**TO:** All Bidders  
**FROM:** City of Cambridge  
**DATE:** December 10, 2013  
**RE:** File No. 5849C –Dr. Martin Luther King Jr. School Construction  
Project- Addendum NO. 2

**Addendum No. 2**

Regarding: Bid Addendum 2 – Administrative

DR. MARTIN LUTHER KING JR. SCHOOL CONSTRUCTION PROJECT  
CAMBRIDGE, MA  
FILE NO. 5849C

PROJECT NO. 47931.00  
 SCALE: 3/8" = 1'-0"  
 SHEET  
 REFERENCE:  
 DWG. NO.: **SKS-19**

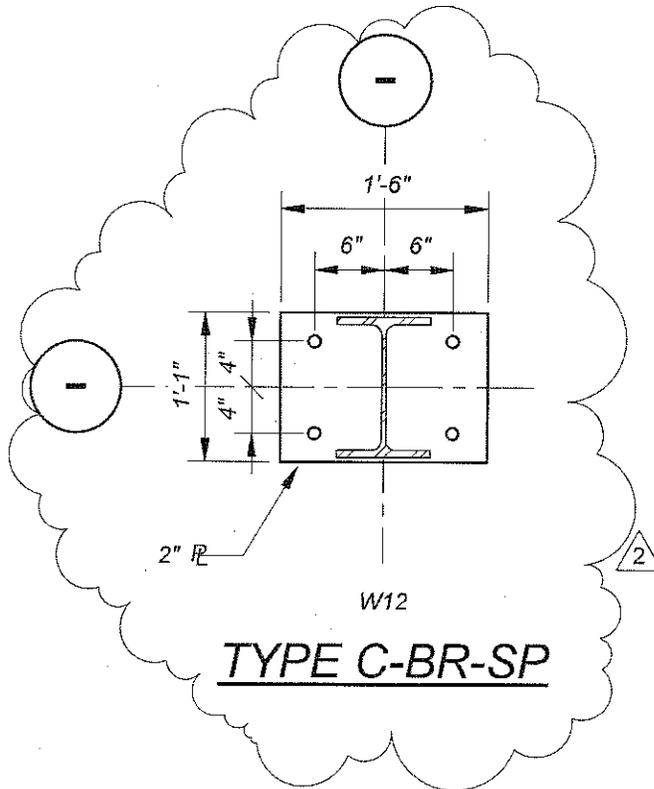
PROJECT: **Dr. Martin Luther King, Jr. School**  
**Construction Project**  
 DRAWING  
 TITLE: Revisions to Special Column Type 10  
 DATE: 12/10/2013 BID ADDENDUM 2

PROJECT NO. 47931.00  
 SCALE: 3/4" = 1'-0"  
 SHEET  
 REFERENCE:  
 DWG. NO.: **SKS-20**

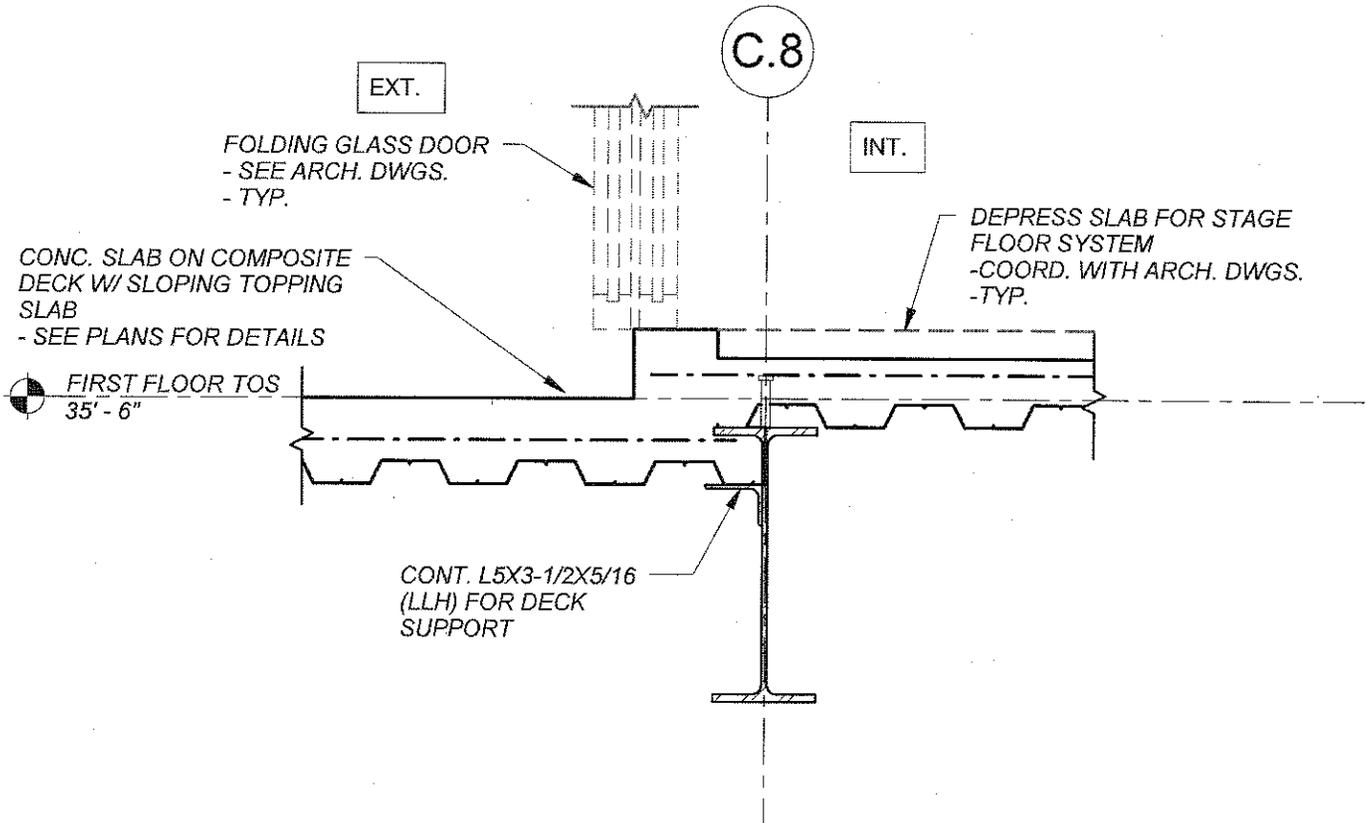
DRAWING  
 TITLE: New Base Plate Type on S210

PROJECT NO. 47931.00  
SCALE: 1/2" = 1'-0"  
SHEET REFERENCE:  
DWG. NO.: **SKS-23**

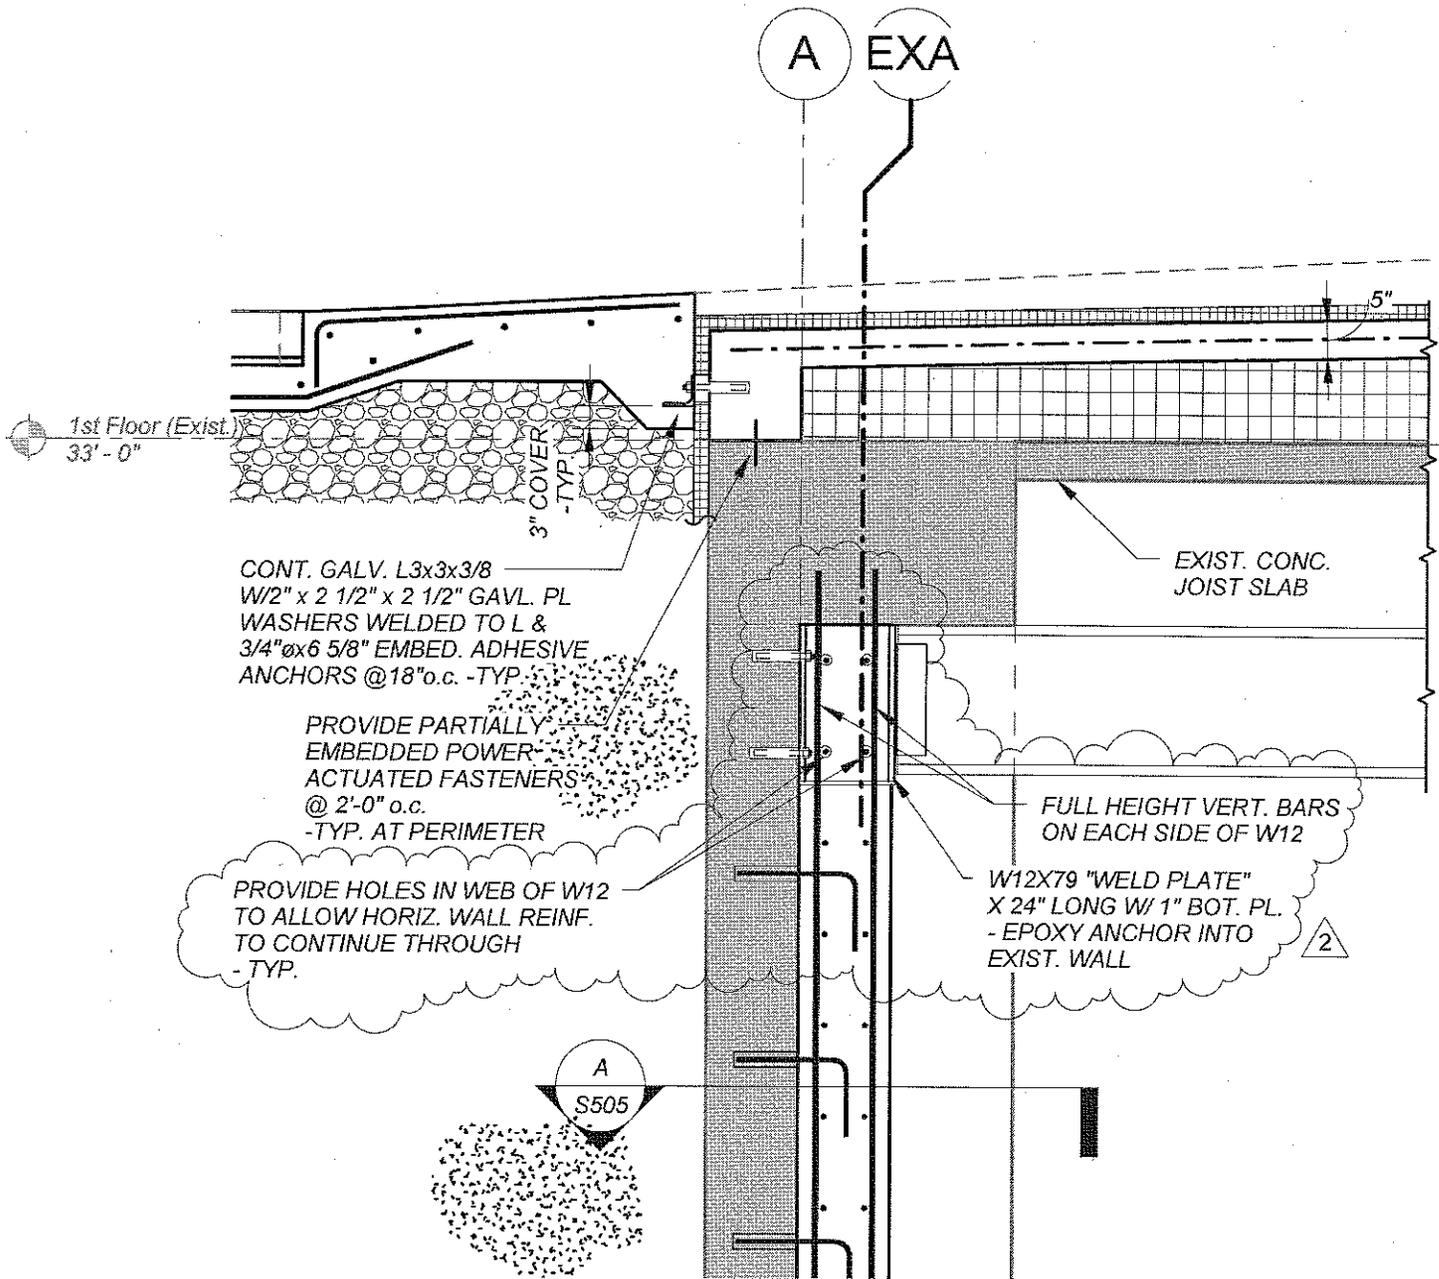
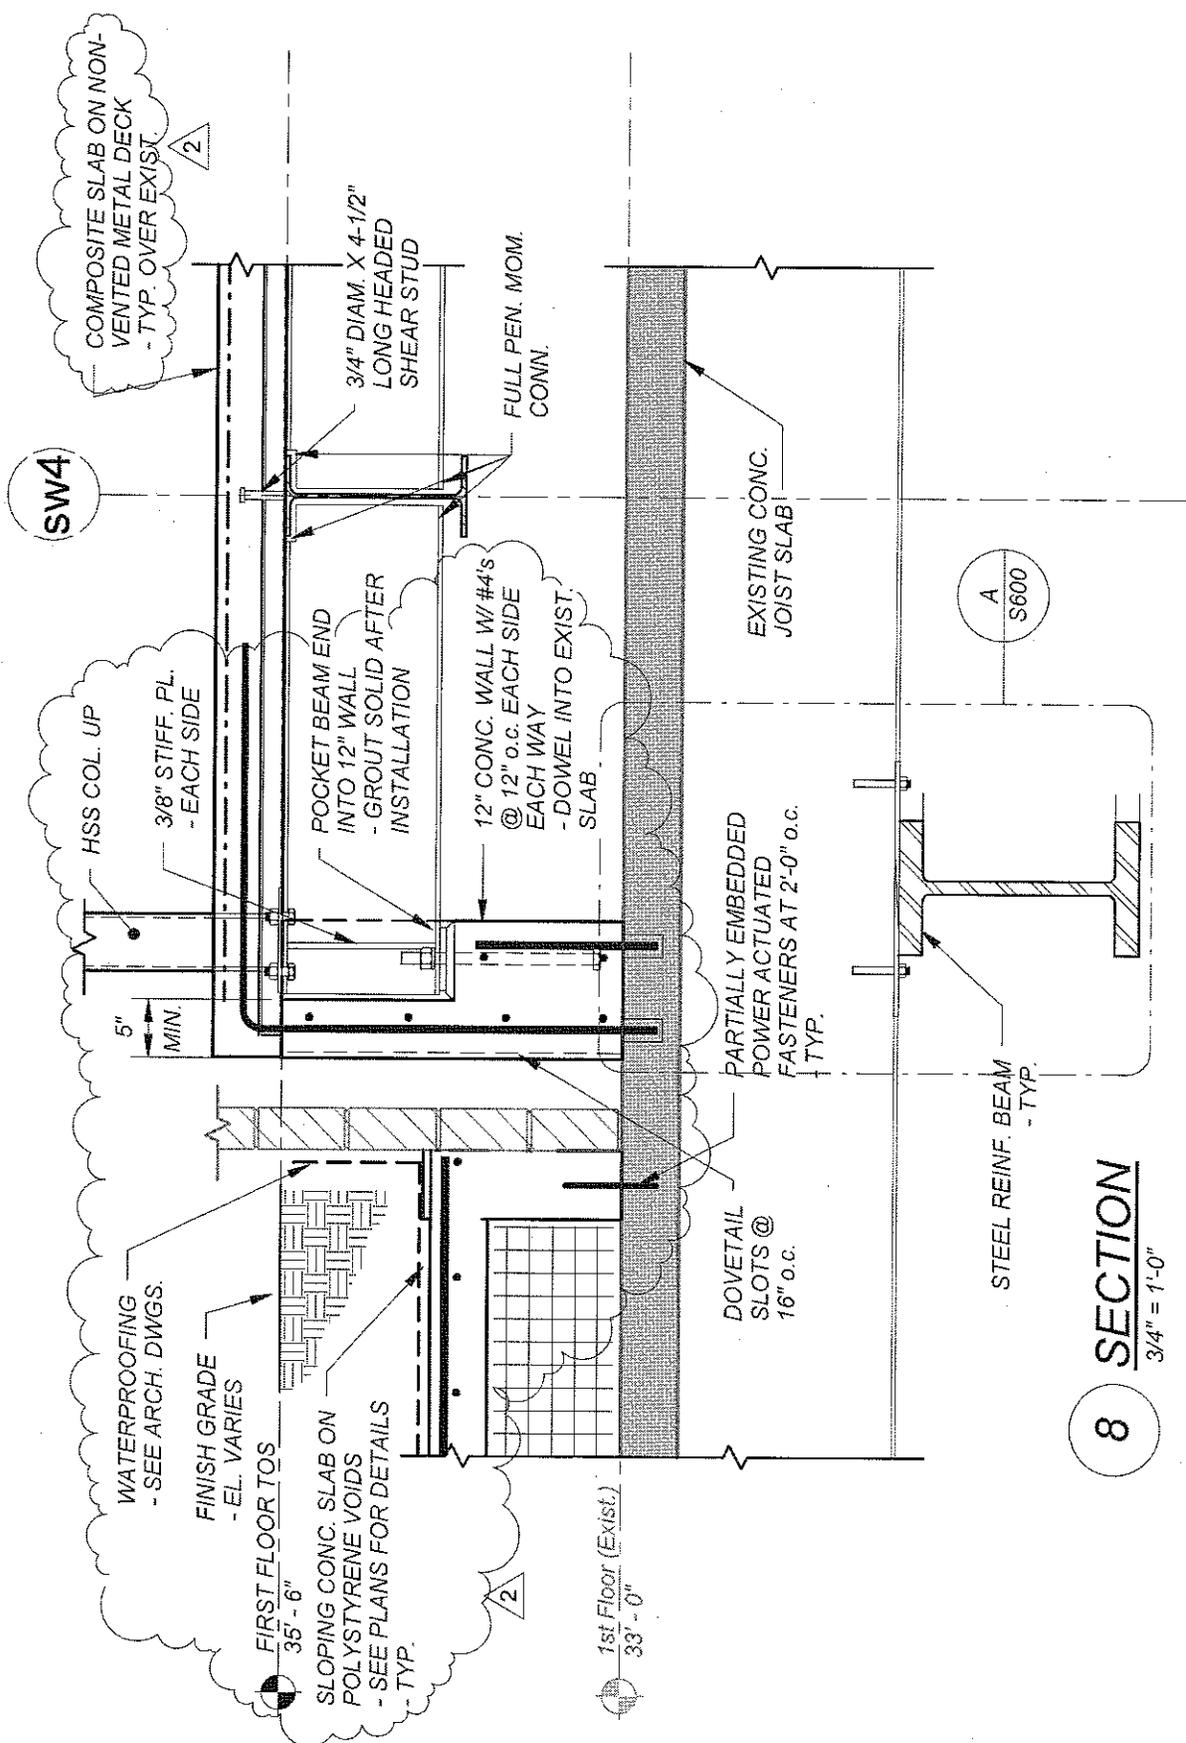
PROJECT: **Dr. Martin Luther King, Jr. School  
Construction Project**  
DRAWING TITLE: Revisions to Sections 1 and 3 on S504  
DATE: 12/10/2013 BID ADDENDUM 2

**PROJECT NO.:** 47931.00  
**SCALE:** 3/4" = 1'-0"  
**SHEET REFERENCE:**  
**DWG. NO.:** **SKS-25**

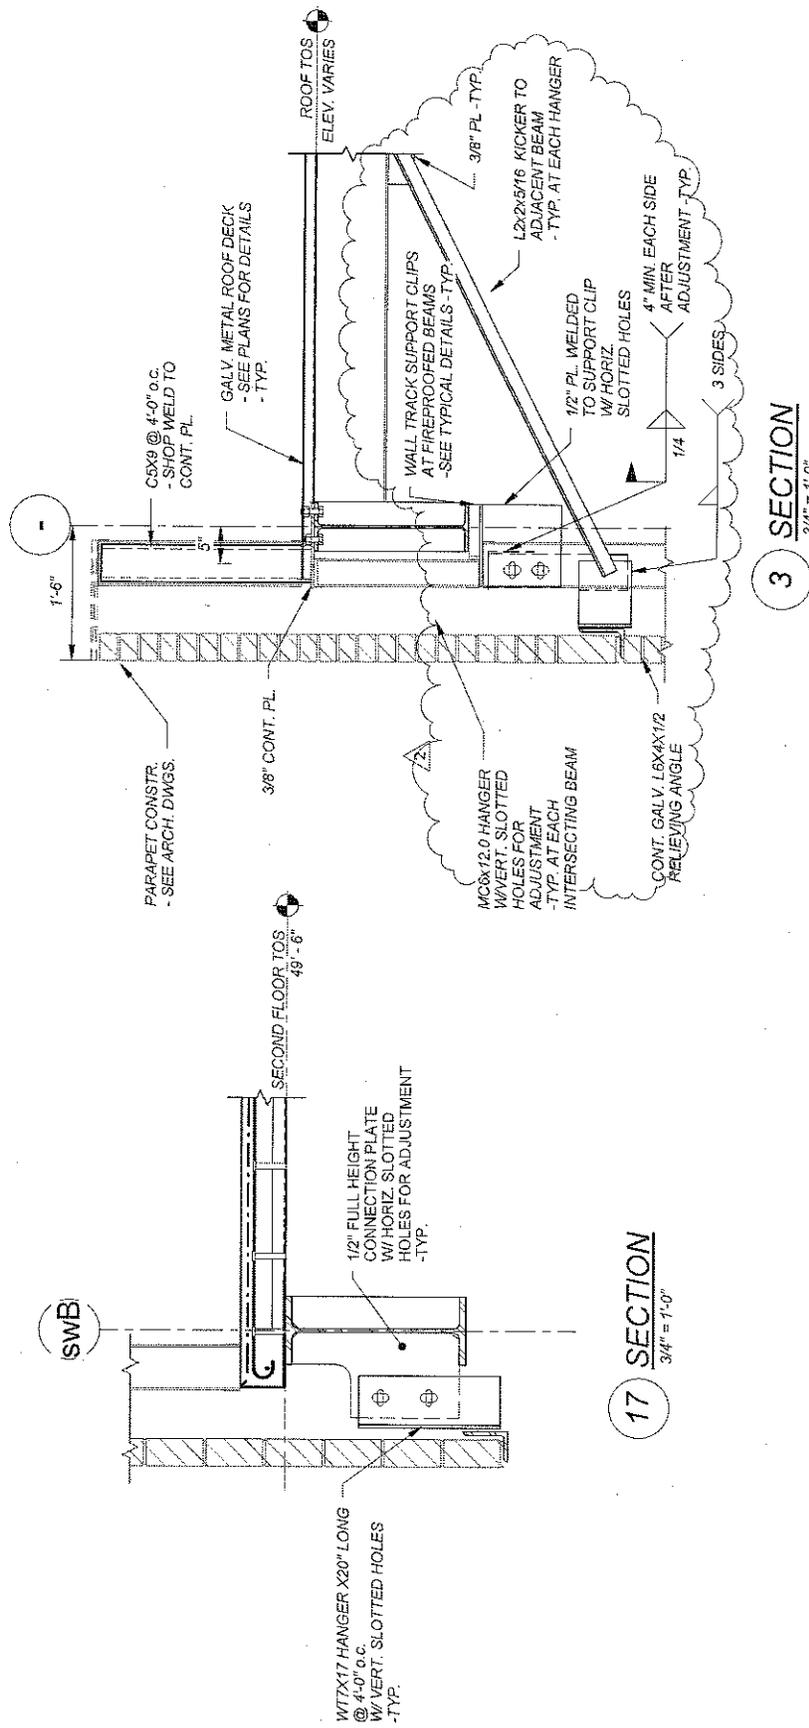
**DRAWING TITLE:** Revisions to Section 8 on S600  
**DATE:** 12/10/2013 BID ADDENDUM 2

PROJECT NO. 47931.00  
SCALE: As indicated  
SHEET REFERENCE:  
DWG. NO.: **SKS-28**

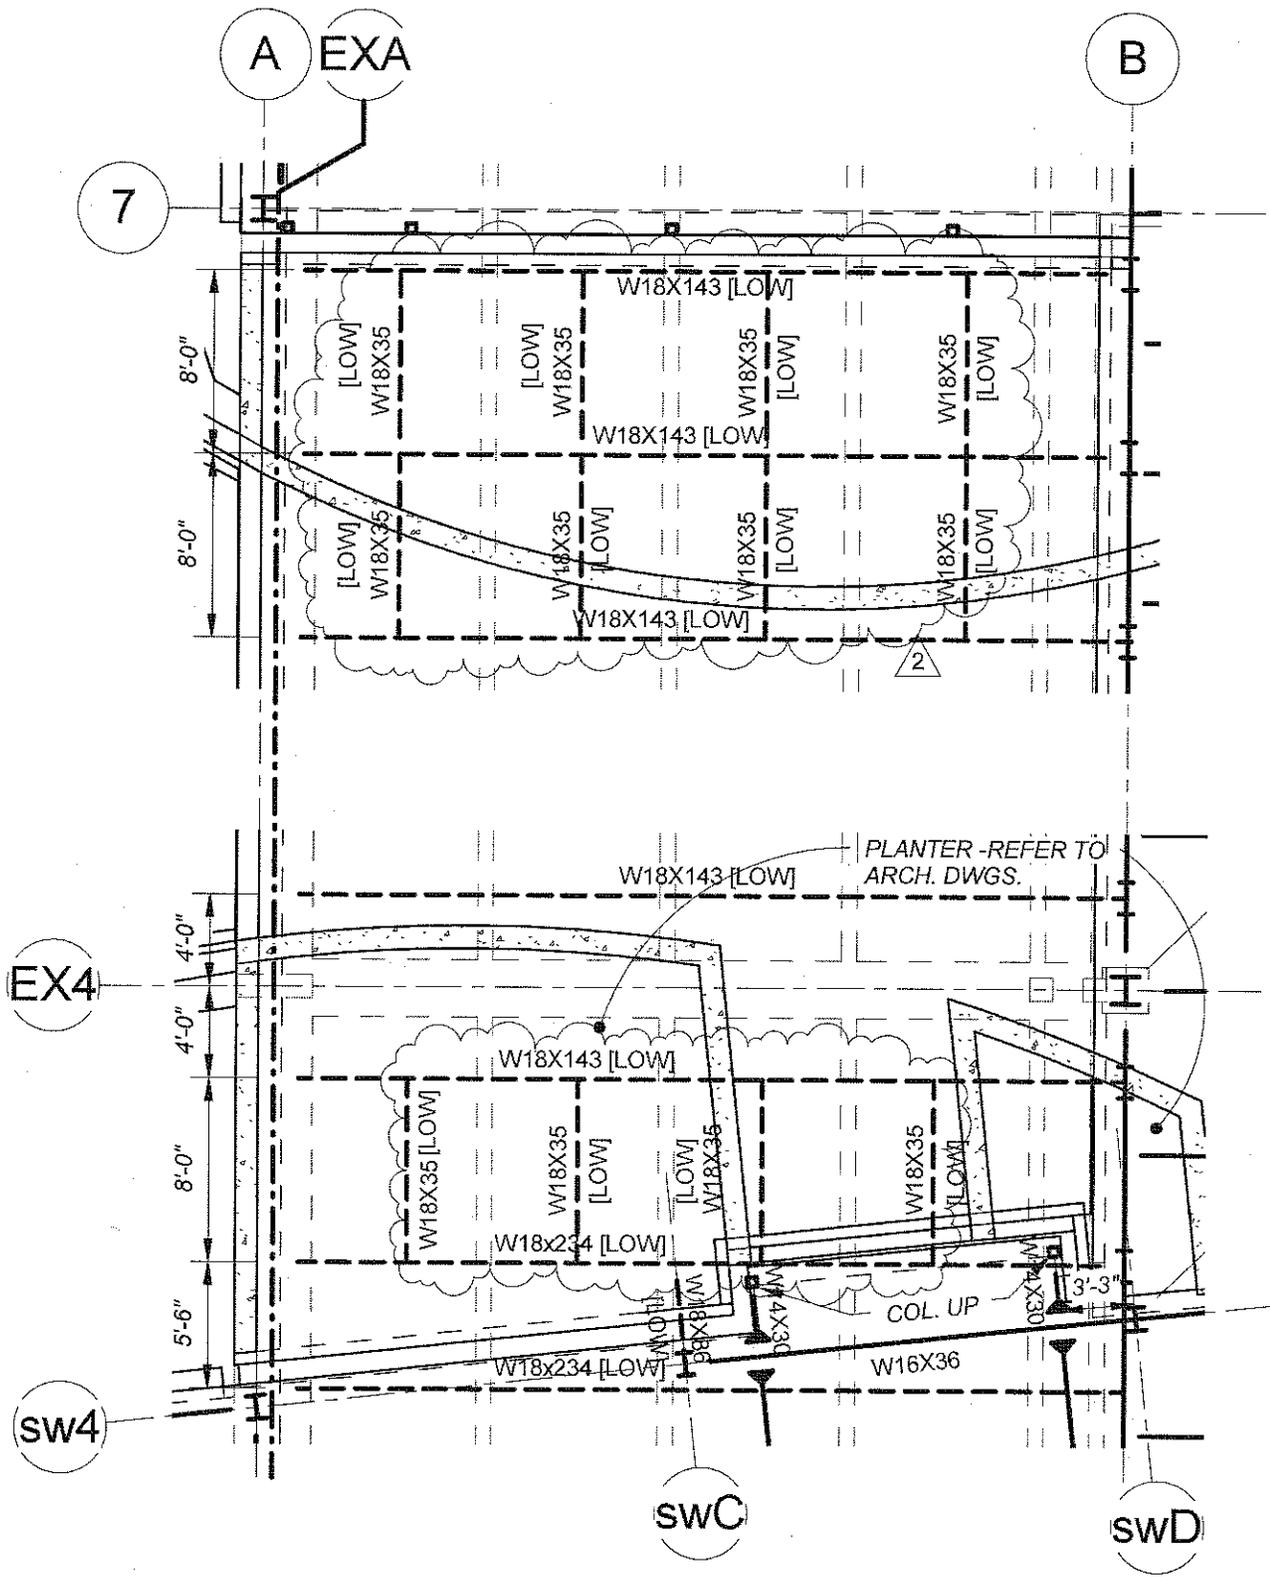
137	Structural	Subject:	Custom Fabricated Beams
		References:	S114.3
		Description:	Revise "Tapered W Beam" tag to "Custom W Beam" at seven locations.
138	Structural	Subject:	Custom Fabricated Beams
		References:	S114.3, SKS-28
		Description:	Add new section reference at Custom W Beam connection to hanger at KS2-neA for Section 6a on S705. See SKS.
139	Structural	Subject:	HSS V Brace Detail
		References:	S203
		Description:	Replace stiffener plate note with "2-1/2" x 3/8" (min.) thick stiffener plate each side"
140	Structural	Subject:	Base Plate Notes
		References:	S204, S205, S206
		Description:	Add the following to Note 2: "Base plate elevations at columns bearing on existing footings or walls are to be verified in field" Replace "S209" with "S210" in Note 2 Replace "S208" with "S208 and S209" in Note 3.
141	Structural	Subject:	Base Plate Thermal Isolation
		References:	S204, S205, S206
		Description:	Eliminate thermal isolation plate below exterior steel columns and steel columns in the Garage.
